Platform A1 - Booth area  
Previous comments are  
still valid, see following  
slides

Important: the 12 columns of the Spray Booth have been modified after change of the Scrubber technology by Renault-VAZ

Axes 8/012

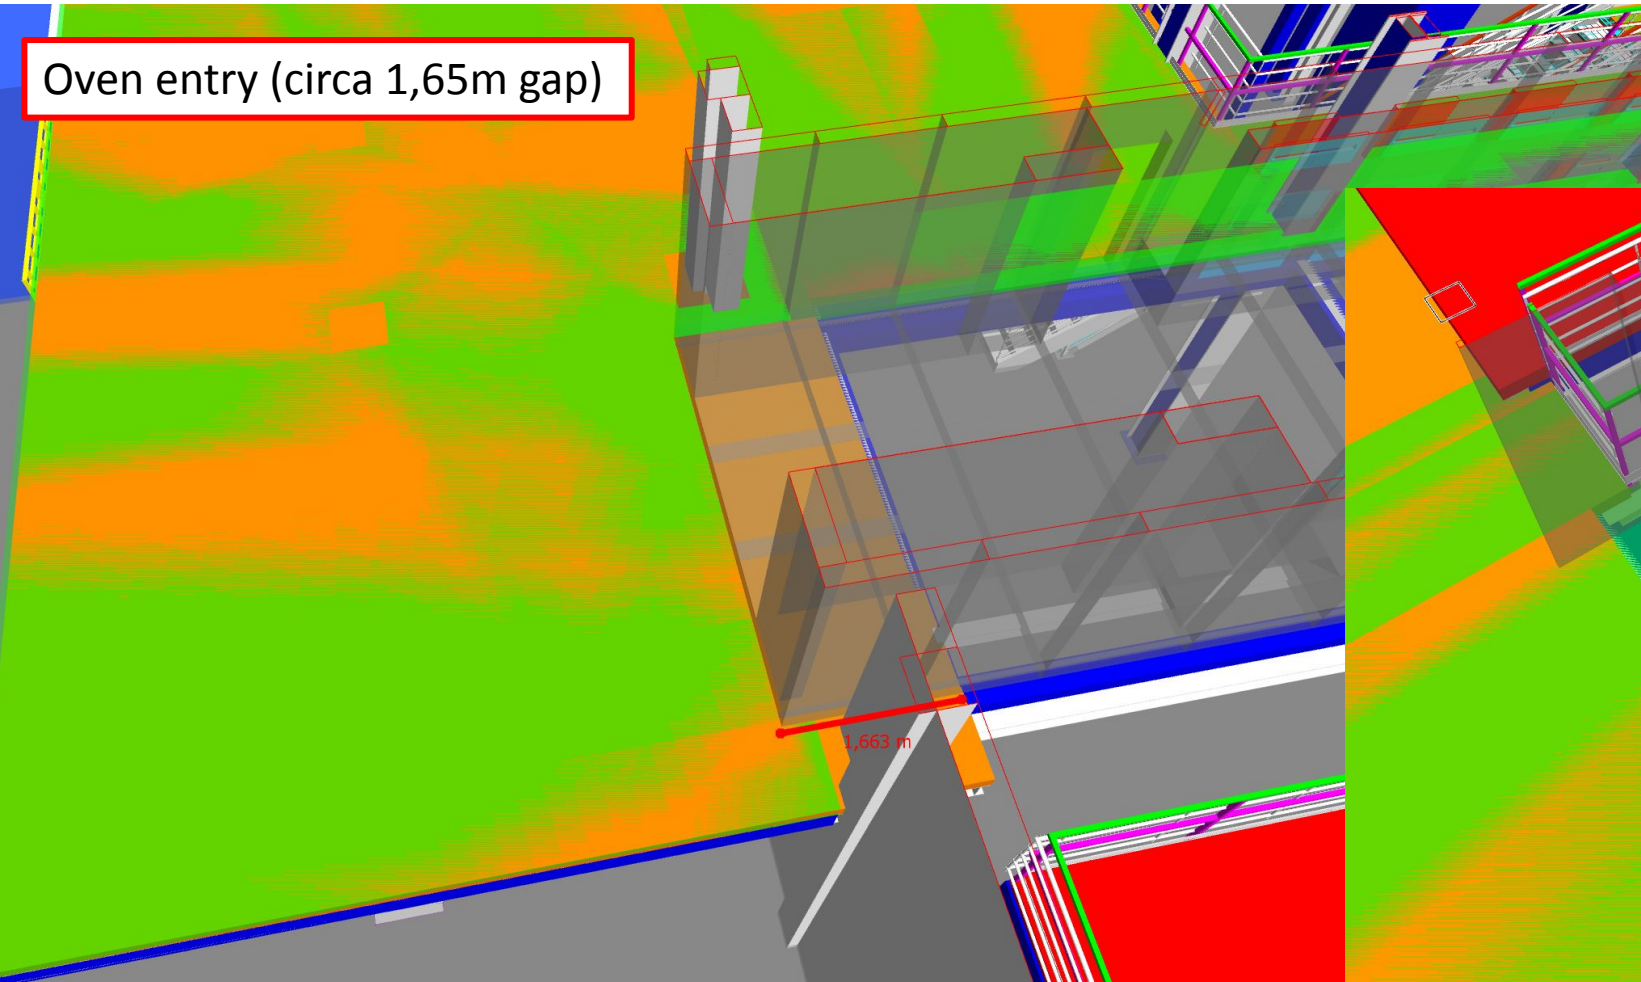
Be sure to respect Oven perimeter when modeling walkable modules around it

Oven center axis is positioned 3m west of axis 8

Axes 7-8/013

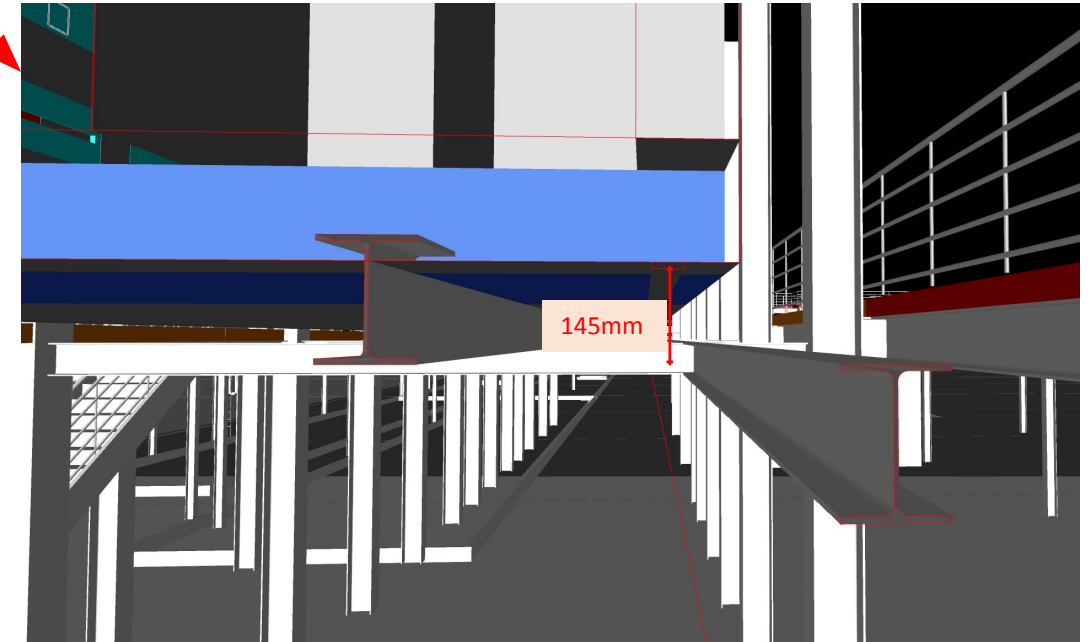
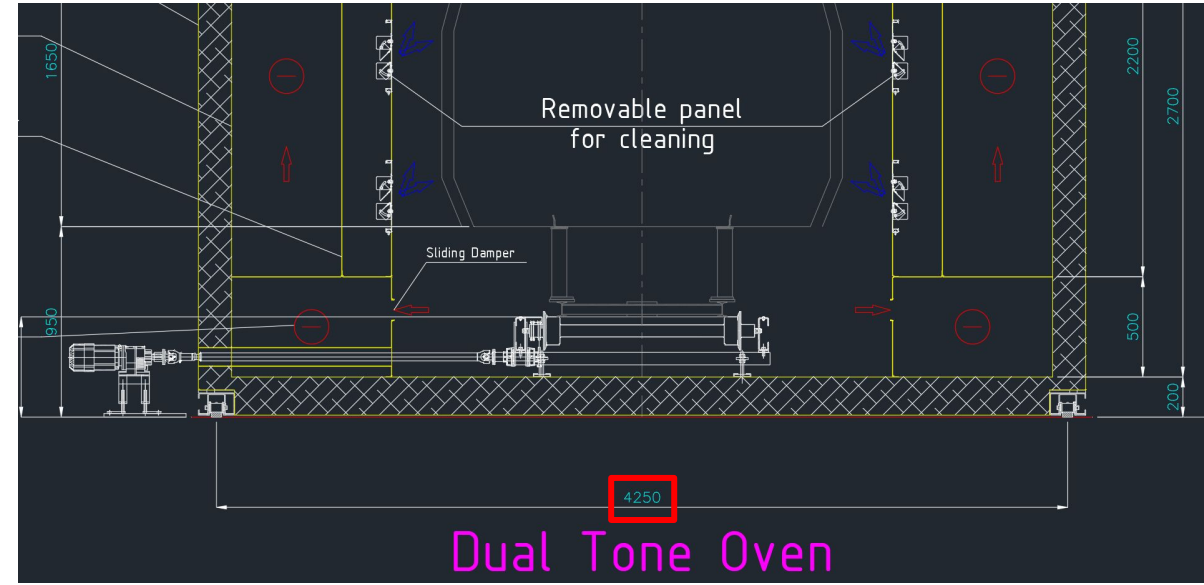
Update (08/06): the Oven load is only transferred to the two longitudinal beams on each side, there's no need to put more beams in the middle;  
Also, the beams have to be no more than 145mm.

## Axes 7-8/012-019

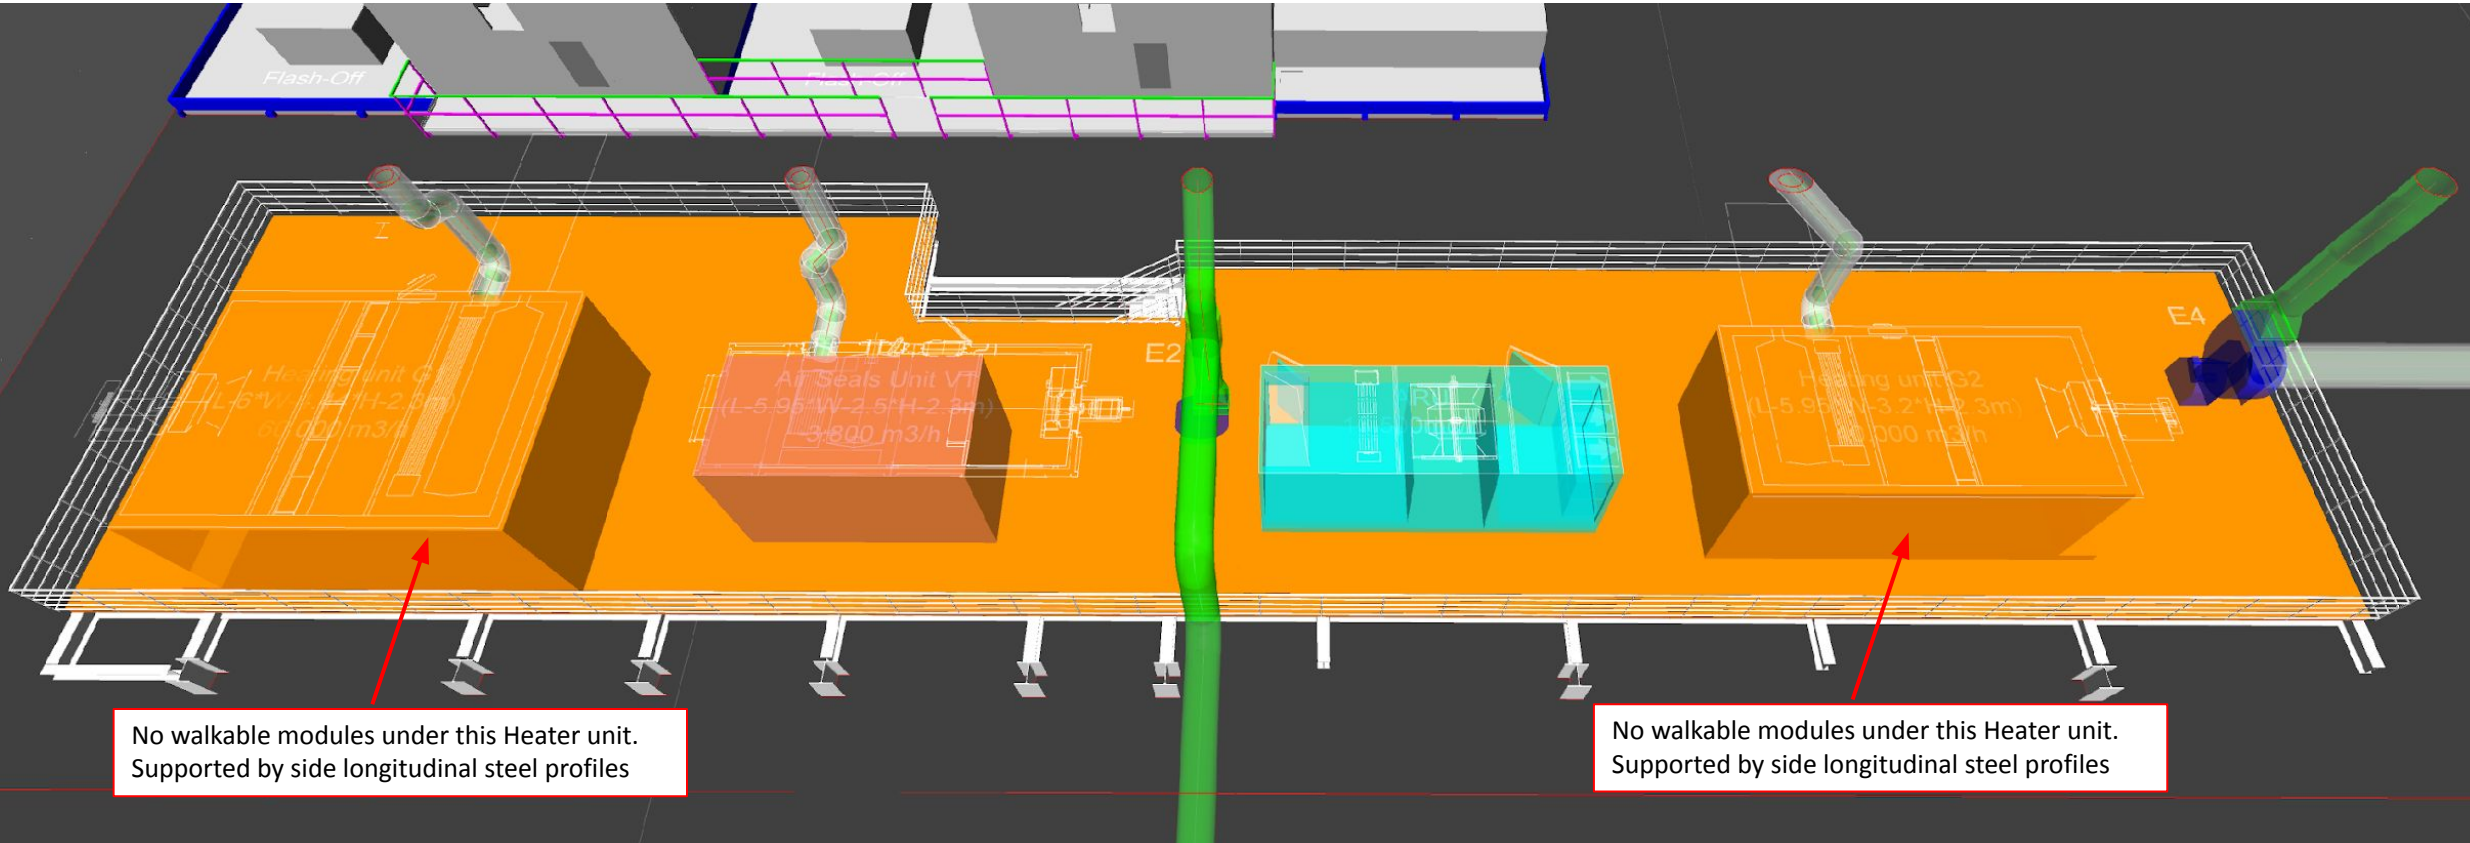
Keep in mind that we have ducts penetrating platforms under the two Heater groups, these ducts will have insulation (150mm all around). I will submit information about these duct location in order to avoid clash with supporting beams

No walkable modules under this Heater unit. Supported by side longitudinal steel profiles

No walkable modules under this Heater unit. Supported by side longitudinal steel profiles

Platform A2 – Demasking & IRC area (axes 8-10/013-015):

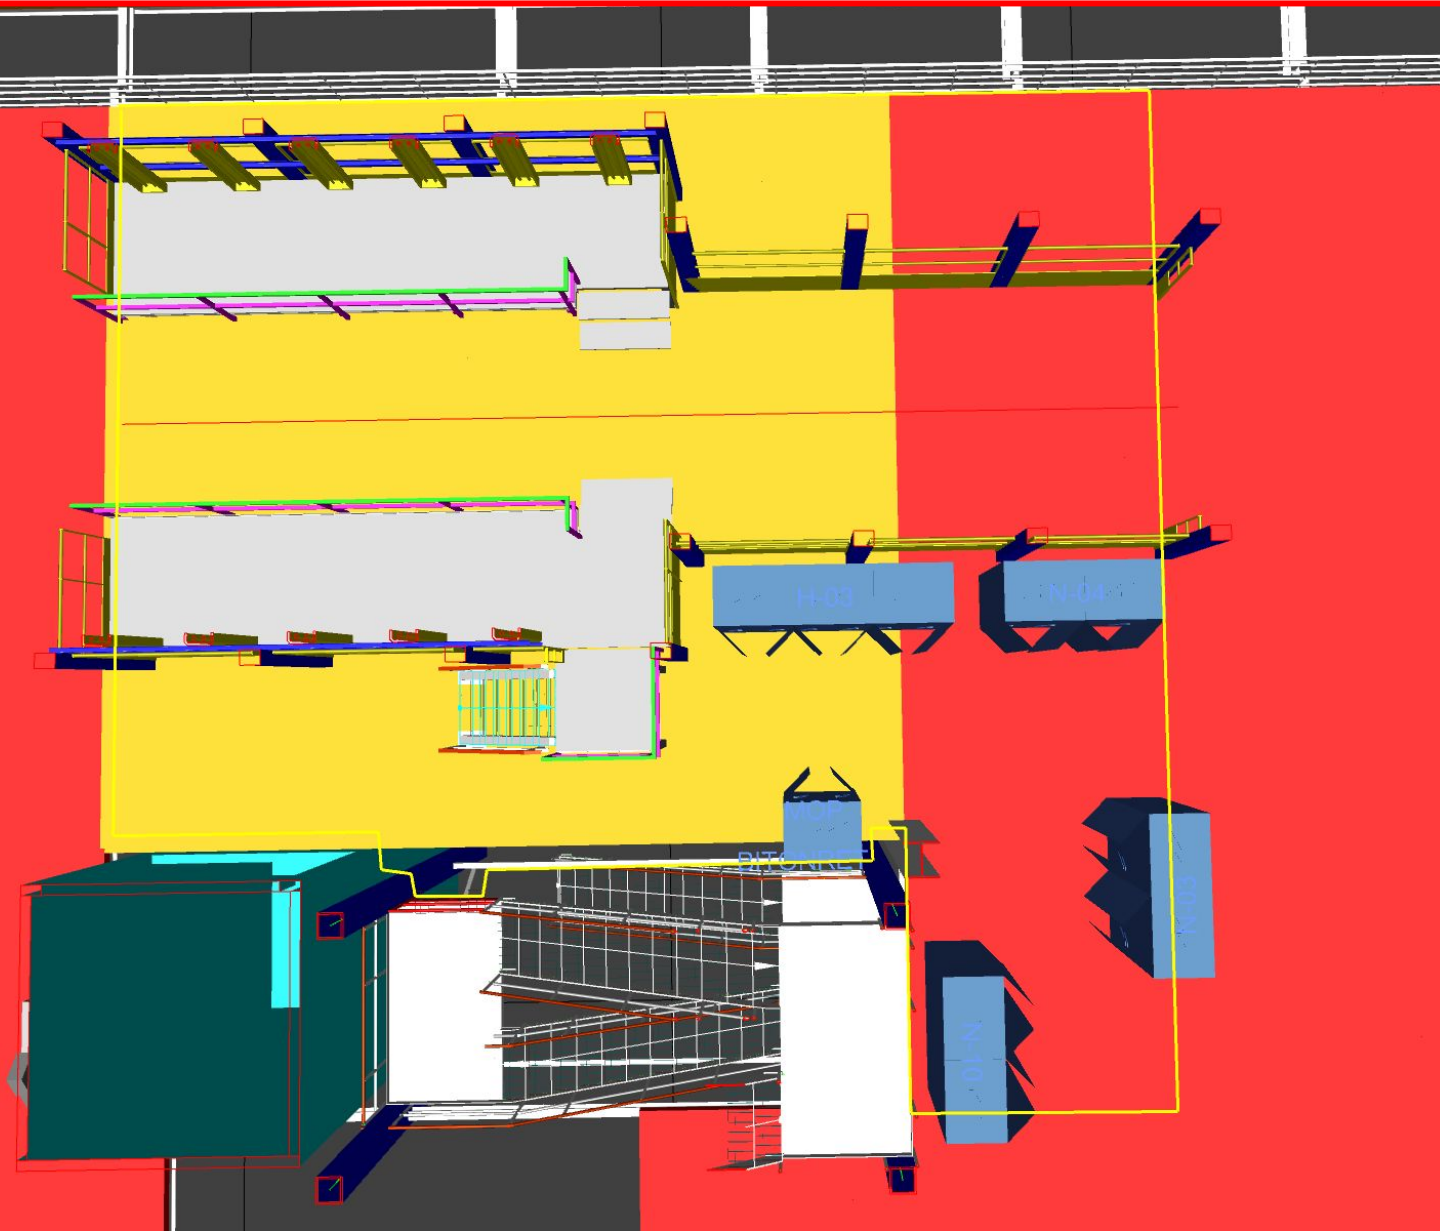
The area to be covered with walkable modules shall be the one circled in Yellow, basically under the two open Booths and under Electrical cabinets, as shown on General Layout uploaded in drive on 04 April (rev E – in progress)

Update:  
Comment still valid

Platform A2 – Elevators area (axes 10-12/013-014):

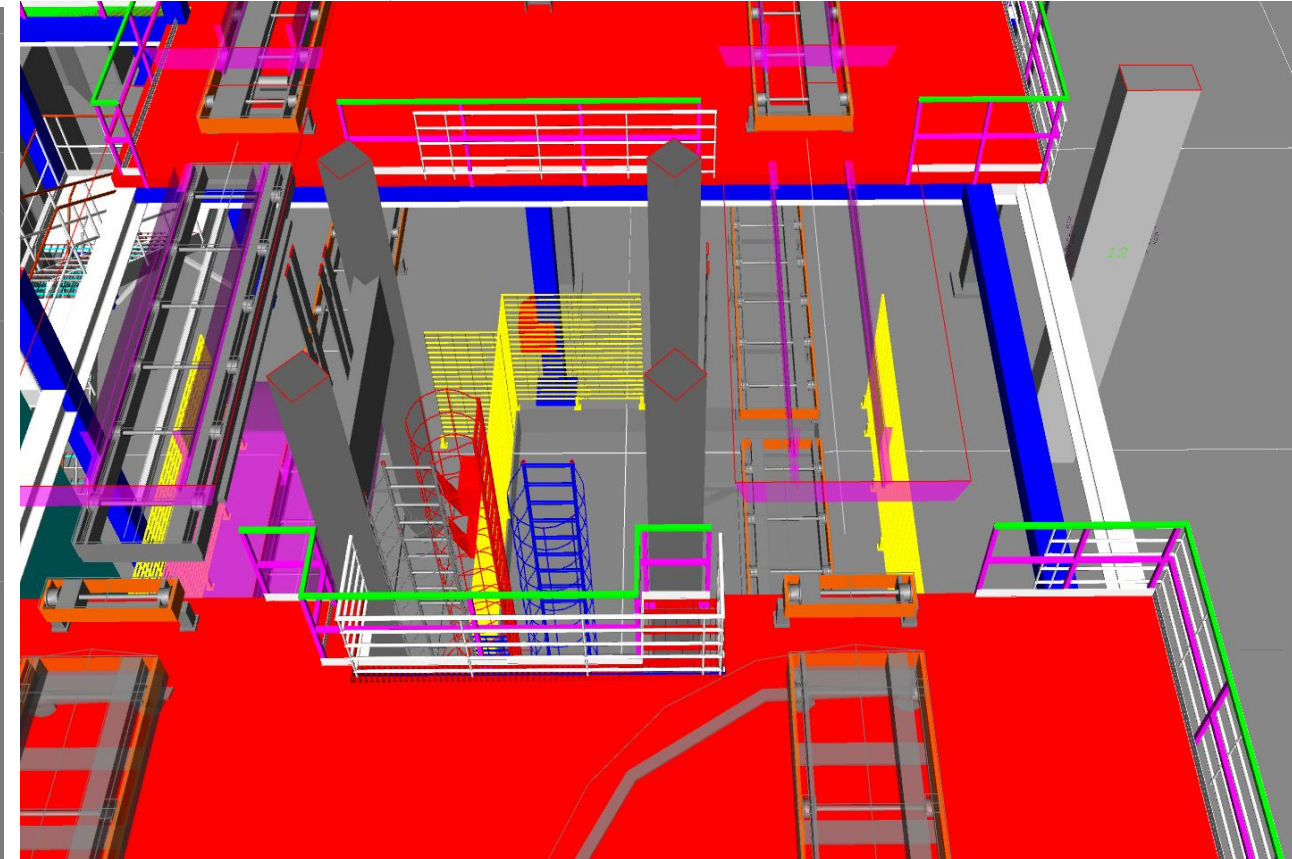
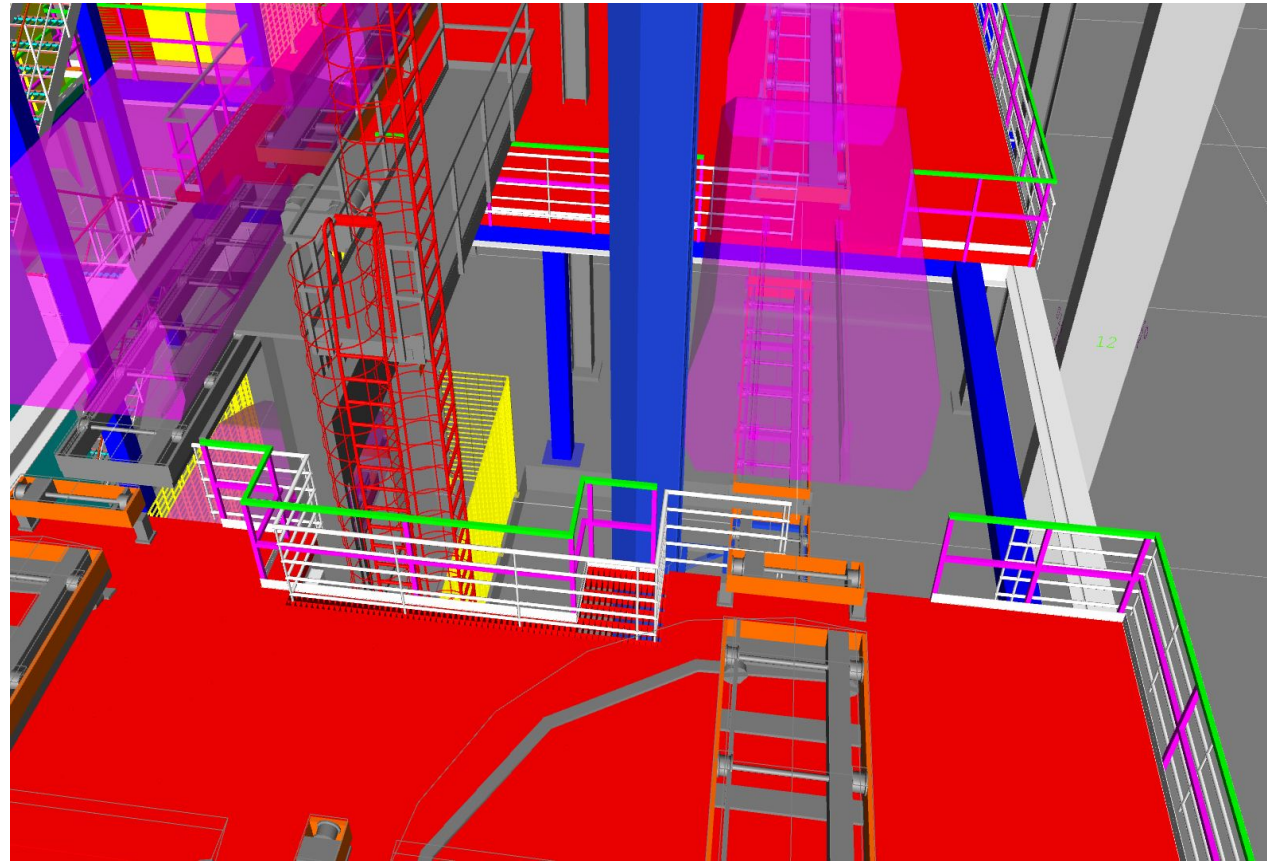
Update:  
Still not correct, use General  
layout to see handrails and  
platform configuration!
